MASTER DEVELOPMENT/ P.U.D. PLAN
for
BIRDWELL - STONEOAK
SUBDIVISION

MASTER DEVELOPMENT/ P.U.D. PLAN
for
BIRDWELL - STONEOAK
SUBDIVISION

City of San Antonio
Development Services Department
Master Development Plan
APPLICATION

The City Staff Development Review Committee has reviewed **Birdwell - Stone Oak** Master Development Plan M.D.P. # 833. Please find enclosed a signed copy for your files. Your plan was accepted however please note the following:

GATE DETAIL
(TYPICAL FOR GATE ENTRANCES)

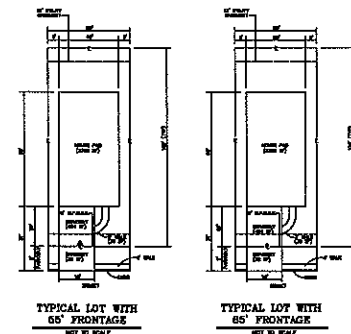
1. The above referenced MDP/PUD is approved with the following conditions:
 - a. By UDC standards, a Local B Street requires 40 feet of pavement.
 - b. On the gate detail, change the arterial side pavement widths to 24 feet on both sides.
 - c. Clarify note 8 reference sidewalks in public right-of-way. It appears that some portion of all internal sidewalks will be in the pedestrian easement.
2. It should be understood that this is a general review of a conceptual plan and that ***all*** technical requirements of the Unified Development Code for Streets & Drainage shall be complied with.
